TECHNICAL BULLETIN
LTB00304NAS8
31 MAY 2013

SECTION: 310-00

Fuel Gauge Operation / DTC U0128-00 Stored

LR4 (LA)	Model Year:	2010-2013
	VIN:	AA510178-DA656034
Range Rover Sport (LS)	Model Year:	2010-2013
	VIN:	AA212145-DA790997

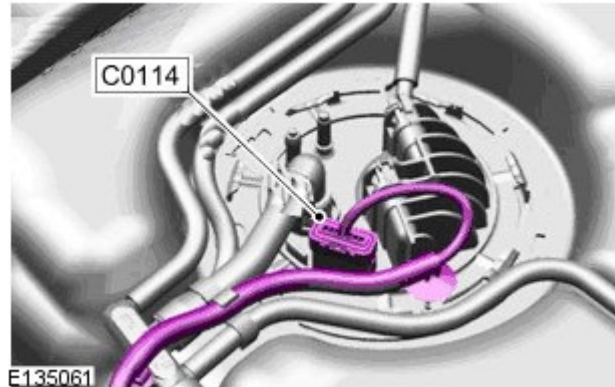
13. The first area to check before commencing any further work is the vehicle harness to fuel tank connection. A poor connection may exist where the harness plugs into the flange.

1. To test, with the ignition turned 'OFF' and connector in place, pull the connector upwards to give a worse case scenario connection situation.

2. Turn the ignition 'ON'.

- does the gauge drop to zero?

3. Repeat several times.

- If fault is found, remove connector and ensure pin connections are not loose and that they are correctly retained in the connector housing.
- If no fault can be found, confirm the connector is fitted and pushed fully home and continue with further diagnostics as detailed TOPIX Workshop Manual section 310-01C / D: Fuel Tank and Lines Diagnosis and Testing.
